Author's response

This paper summarizes the results of a global unstructured mesh configuration for the WW3 model that uses high resolution to resolve small islands in the tropical ocean. The model spans

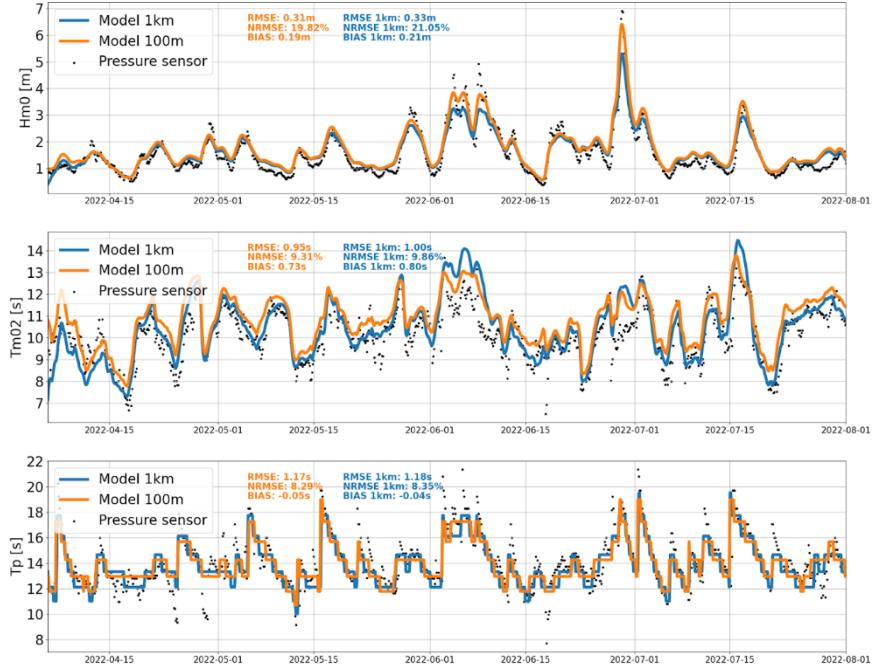
7. The results in Section 3.2 are quite good, but I feel like they could be further strengthened and made more impactful by showing how the wave bulk parameters improve with resolution. For example, it would be really useful to see what 100m resolution buys you in terms of accuracy vs the 1km used for other islands. This would give the reader more guidance on the right level to use for their given application. I understand there may be restrictions here as it relates to resolving the actual observation location. I also understand this would mean developing a new mesh and running more simulations, which may not be practical. However, some commentary on whether 100m there is likely to be a difference between, say 100m and 200m resolution, would be helpful. This is another reason it would be good to be more clear about the local resolution used (see first comment) because that could provide these types of insights as well.

We modified our grid in order to degrade the spatial resolution to 1000 m at La Réunion (see Figure below for the comparison between the two meshes). However, considering the steep bathymetric slopes surrounding the Island, the refinement was too coarse to allow for a consistent water depth in the model and at the location of the pressure sensor so we had to move the output point. Therefore, it is difficult to determine whether the poorer results with the 1000 m resolution are due the poor representation of fast-varying water depths or if they are caused by an interpolation issue. In order to make that point clearer, we added in the revised version of the paper in lines 329 to 332 : *“In order to make clear recommendations concerning the minimum resolution required for such comparisons, we need more adequate measurements and we are waiting for forthcoming high-resolution simulations to carry out comparative studies. Additionally, the issue of resolution remains closely tied to interpolation issues when comparing measurements and model in rapidly varying media.”*

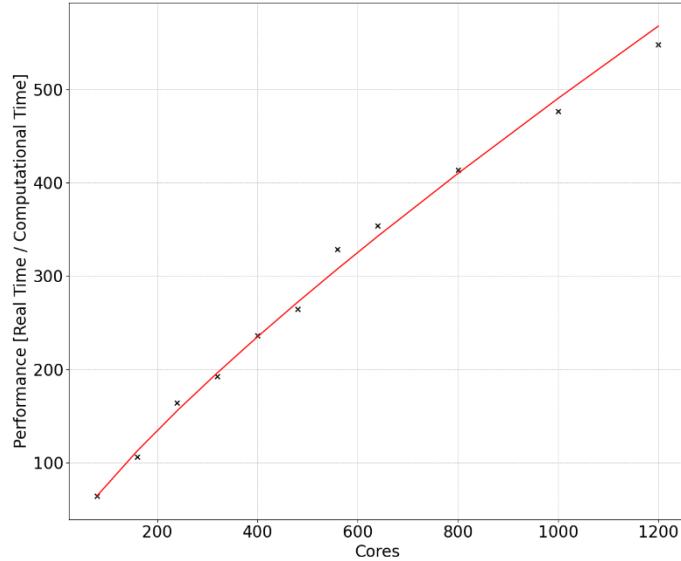
8. More could be said about the computational performance of the model. Line 277 states: “Indeed, for the same computational resources, a one year simulation with implicit scheme took 12 h.” What was the number of MPI ranks used for this to get this throughput and how does the parallel scalability of this configuration compare to Abdolali et al., 2020?

200 MPI ranks were used in the simulation described, which corresponds to 10 nodes with 20 cores per node. The very good model performance and scalability, as Abodali et al. 2020 showed in their paper, are shown one figure 2:

Figure 3 : Normalized RMS error (A) and bias (C) between $Hm0$ deduced from altimetry and simulated with the SG 1h-ERA5_QC configuration and normalized RMS error (B) and normalized bias (D) with the SG 3h-ERA5_QC configuration

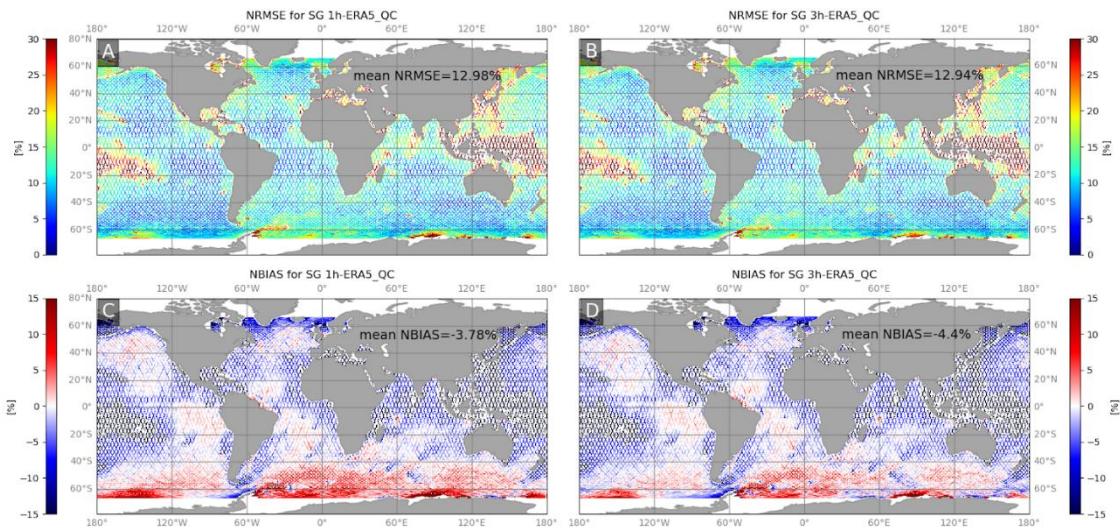
2. Wind Field Temporal Resolution: The choice of 3-hourly ERA5 data might be insufficient for fast-moving systems, such as hurricanes. Given that ERA5 offers hourly data, it would be valuable to understand why 3-hourly data was chosen. Further, suggestions on time interpolation techniques to better capture these conditions would be helpful.

Hourly wind field data were also considered but a sensitivity analysis revealed that it only improved model bias predictive skills by 0.62% and increased the normalized error by 0.04% (see Figure 1). In order to explain our choice we added in the revised version in lines 107 to 108 : *“. ERA5 also offers hourly data but sensitivity tests revealed similar results with 3 hourly wind fields.”*

Figure 4 : Comparison between measured power spectral density modelled and observed at 9:00 UTC on June 8th, 2022 (Hermitage, La Réunion Island). The green lines represent the cut-off frequencies. The black lines represent the peak frequency and the superharmonic frequencies.

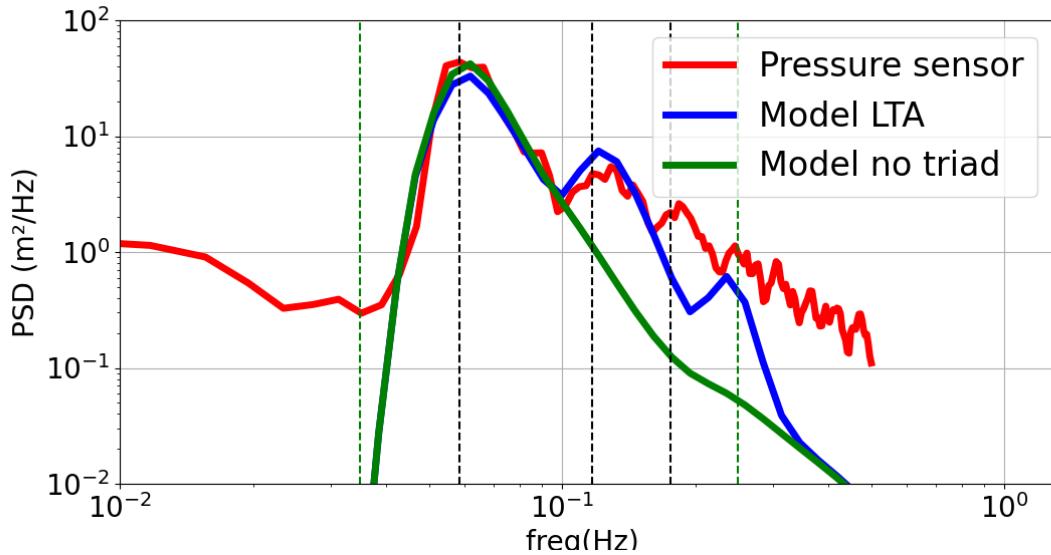
3. Triad Interaction in Shallow Waters: While the study employs triad interactions, the impact on shallow water gauges isn't clearly demonstrated. It would be beneficial to include an analysis of triad effects on gauge results in these areas.

We propose to show the wave spectrum in La Réunion Island at the peak of the DDS event of June 2022, with and without triad interactions (see Figure 2). In the revised version of the manuscript, Fig. 14 was modified accordingly:

Figure 5 : Comparison between power spectral density modelled and observed at 21:00 UTC on March 22nd, 2008 (Pointe de la Grande Vigie, Guadeloupe). The purple line represents the frequency cut-off for the swell partitioning.

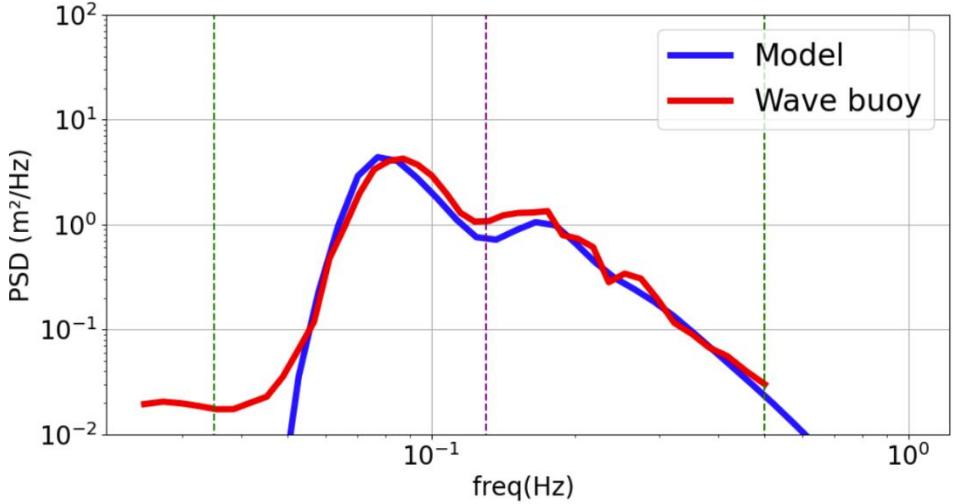
5. Quantifying Swells without Partitioning: The paper does not describe a method for separating wind-sea and swell partitions, which is essential for accurately quantifying swells (this is the main argument of this paper). Swell partitioning would allow better comparison between modeled and observed swells and enhance understanding of the model's performance across different wave types. This would be beneficial, especially in coastal observations, to assess model accuracy across partitions.

In order to separate wind-sea and swell partitions, directional spectrum data exposed to wind sea and swell are required. As the sensors deployed in La Réunion and New Caledonia are located along the leeward coast of these islands, they were not exposed to wind waves generated by trade winds and hence were not considered for this analysis. We focused on the Guadeloupe wave buoy, which was exposed to trade wind sea and for which directional spectra were available. Because wind measurements required to compute the wave age were not available at this station, the spectral partitioning using a frequency cut (PTM5 in WW3) seems the most adapted in our case. Considering frequencies where both wind waves related to trade winds and DDS are present, a minimum can be observed at about 0.12 Hz (see figure 3), which we used to

separate swells and wind waves. Integrating the wave spectrum with this frequency cutoff, one can see that the model reproduces DSS and wind waves with a similar accuracy (see figure 4). However, as satellite data from the missions used in this study and most wave buoys do not allow access to wave spectra, we do not think that this analysis should be integrated in manuscript.
